**NPDES PERMIT FACT SHEET
INDIVIDUAL INDUSTRIAL WASTE (IW)
AND IW STORMWATER**

Application No. PA0082881
APS ID 312508
Authorization ID 1335891

Applicant Name	<u>Howmet Aerospace Inc.</u>	Facility Name	<u>Howmet Aerospace Former Alcoa Lancaster Works</u>
Applicant Address	<u>201 Isabella Street</u> <u>Pittsburgh, PA 15212-5872</u>	Facility Address	<u>1660 Fruitville Pike</u> <u>Lancaster, PA 17601</u>
Applicant Contact	<u>Henk Van Der Meyden</u>	Facility Contact	<u></u>
Applicant Phone	<u>(843) 296-3359</u>	Facility Phone	<u></u>
Client ID	<u>74657</u>	Site ID	<u>237366</u>
SIC Code	<u>4959</u>	Municipality	<u>Lancaster City</u>
SIC Description	<u>Trans. & Utilities - Sanitary Services, Nec</u>	County	<u>Lancaster</u>
Date Application Received	<u>December 8, 2020</u>	EPA Waived?	<u>Yes</u>
Date Application Accepted	<u>December 16, 2020</u>	If No, Reason	<u></u>
Purpose of Application	<u>NPDES Renewal for discharges from a Groundwater Remediation System (GRS)</u>

This is a renewal application of NPDES Permit No PA0082881 for Howmet Aerospace (f/k/a Arconic Inc.) – former Lancaster Works for the discharge of treated groundwater from a groundwater treatment system (GWTS).

Figure 2. Site Plan.

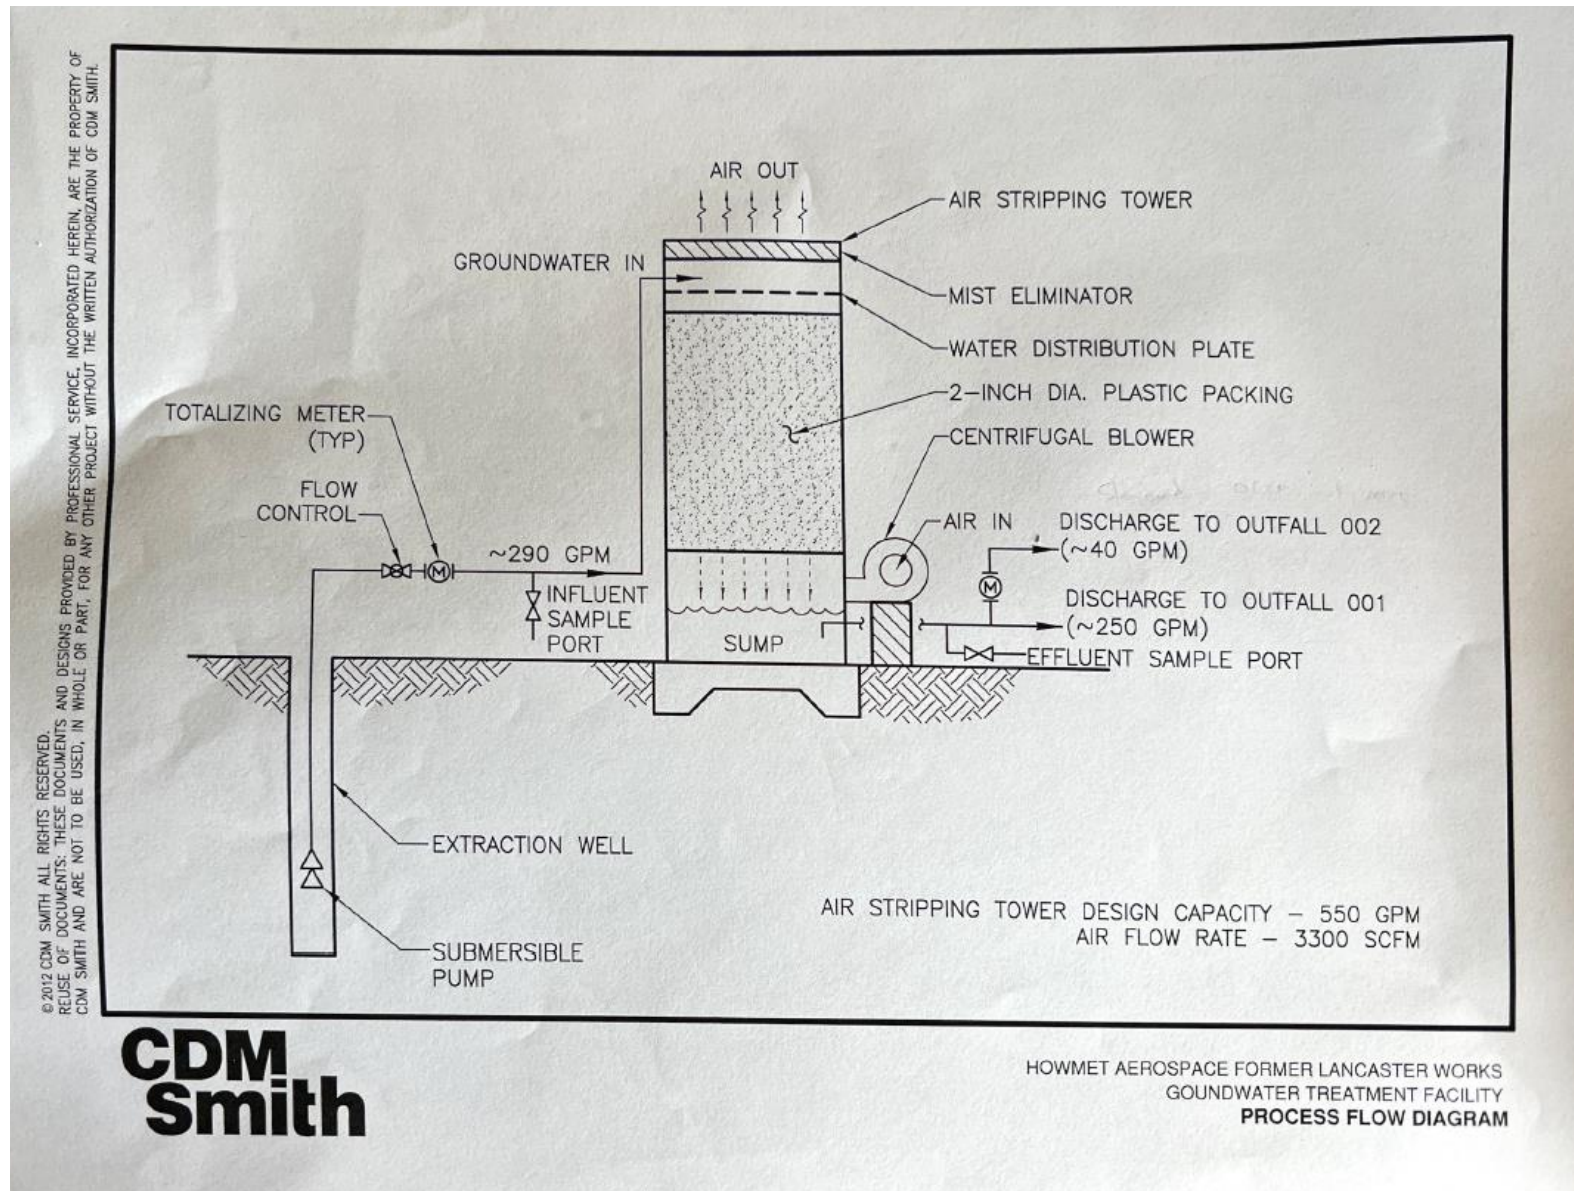
- i. If yes, when did the operations / discharge resume
 - ii. If no, are there any plans to restart the treatment system / resume discharging?
2. Outfall locations. The latitude and longitude for Outfall 001 and Outfall 002 provided in the application do not line up with the locations shown on the Overall Site Plan included in the application. They also do not match the information we currently have in our system.

- a. Please provide corrected latitudes and longitudes for both Outfall 001 and Outfall 002 that line up with their locations show on the site plan.
 - b. Will any of the repairs to the Outfalls affect their locations? If so, please provide the information for the changes, along with a revised site plan.

2. **Outfall locations.** The latitude and longitude for Outfall 001 and Outfall 002 provided in the application do not line up with the locations shown on the Overall Site Plan included in the application. They also do not match the information we currently have in our system.

- a. Please provide corrected latitudes and longitudes for both Outfall 001 and Outfall 002 that line up with their locations show on the site plan. **Corrected lat/long are provided below for each outfall:**

- i. **Outfall 001: 40 deg, 3 min, 47.6 sec N ; 76 deg, 19 min, 13.3 sec W**
 - ii. **Outfall 002: 40 deg, 3 min, 55.7 sec N ; 76 deg, 19 min, 6.4 sec W**

- b. Will any of the repairs to the Outfalls affect their locations? If so, please provide the information for the changes, along with a revised site plan. **No, the outfall pipe replacement will not change the outfall locations.**

Figure 3. Process Flow Diagram.

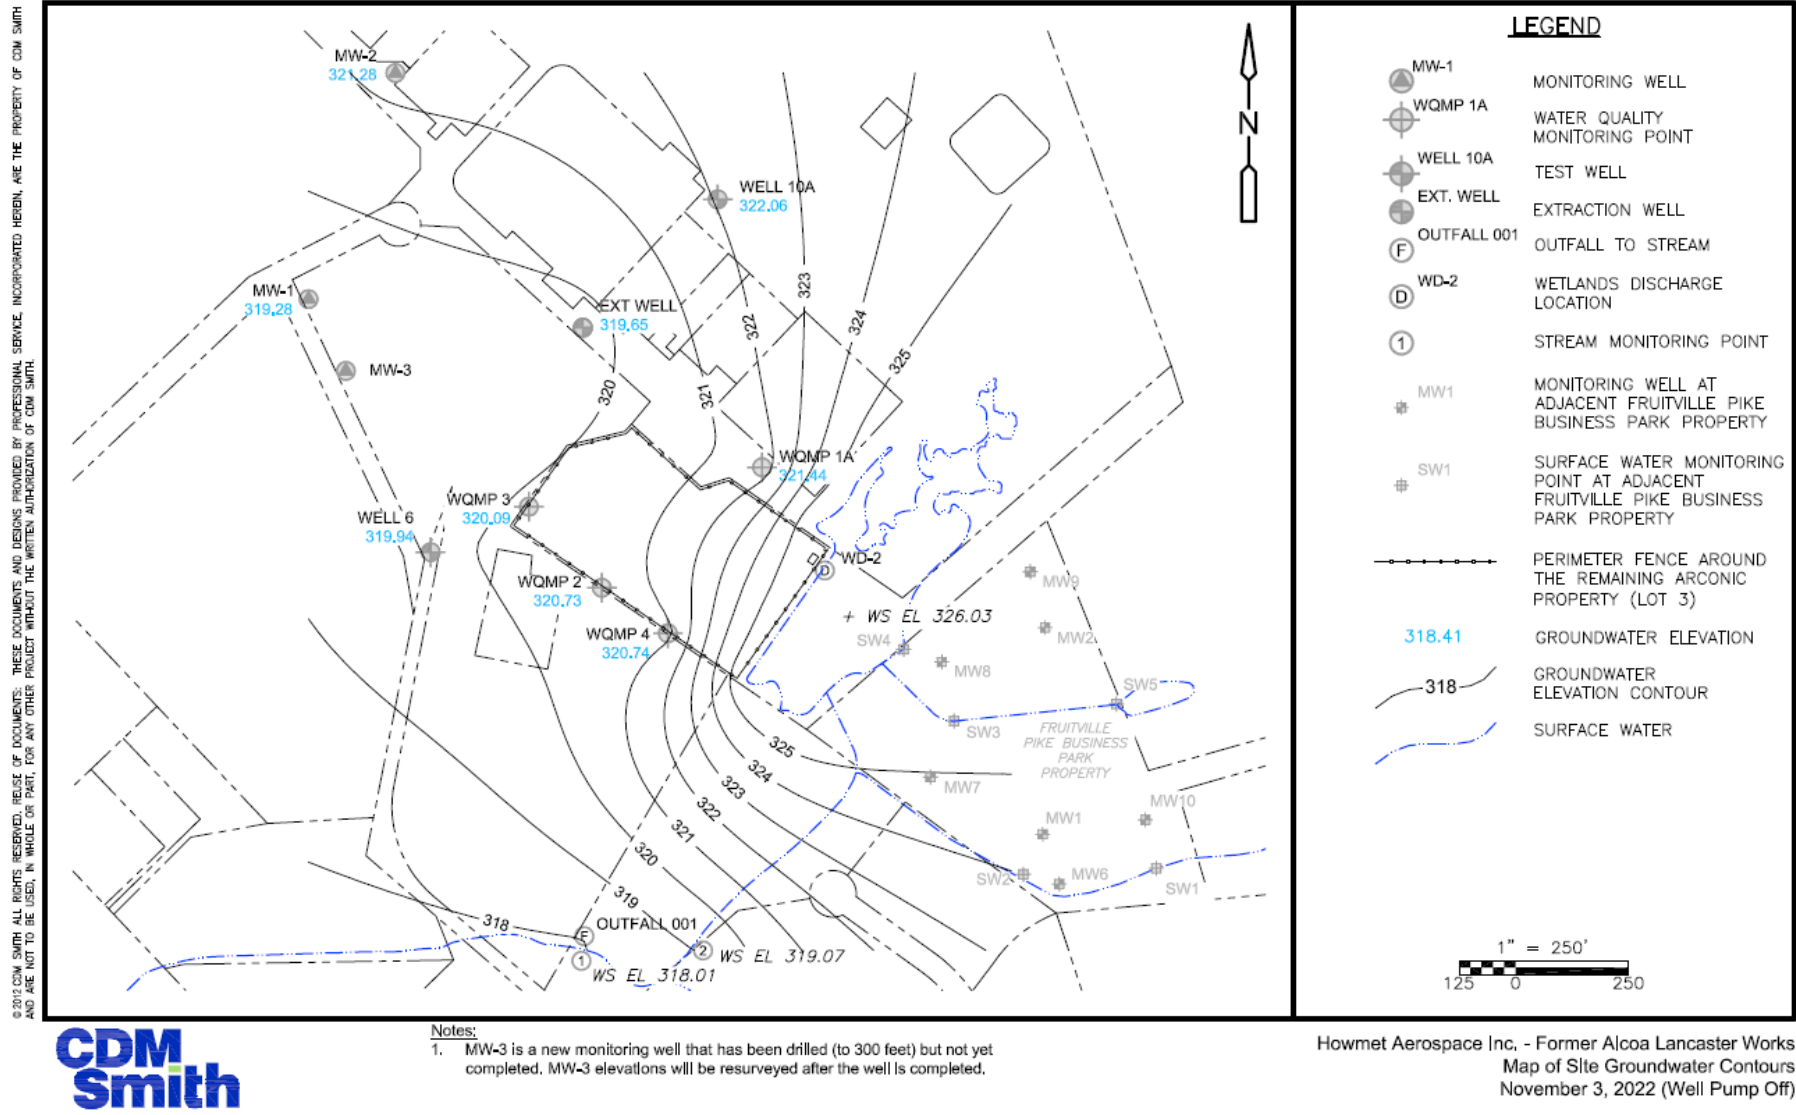
Other Comments: This was previously listed as Outfall 001; however, I am updating it to better reflect where the samples are taken according to the process flow diagram.

Other Comments: This was previously listed as Outfall 002; however, I am updating it to better reflect where the samples are taken according to the process flow diagram.
